TSGR1#10(00)0042

TSG-RAN Working Group 1 meeting #10 Beijing, China January 18 – January 21, 2000

Title: CR 25.215-025: Clarification of Observed time difference to GSM cell

Figure 1 Detailed definition of beginning of GSM BCCH 51-multiframe"

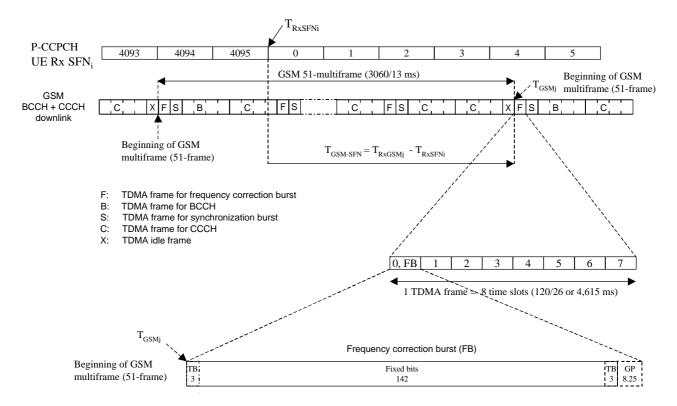
At RAN#6 it was requested to clarify the meaning of "beginning of GSM BCCH 51-multiframe" in the definition of the measurement "Observed time difference to GSM cell" in TS 25.215.

In Figure 1 below a proposed detailed definition of beginning of GSM BCCH 51-multiframe is shown.

It is proposed that the beginning of the GSM BCCH 51-multiframe is defined as the beginning of the first tail bit (TB) of the frequency correction burst in the first TDMA-frame of the GSM BCCH 51-multiframe, i.e. the TDMA-frame following the IDLE-frame.
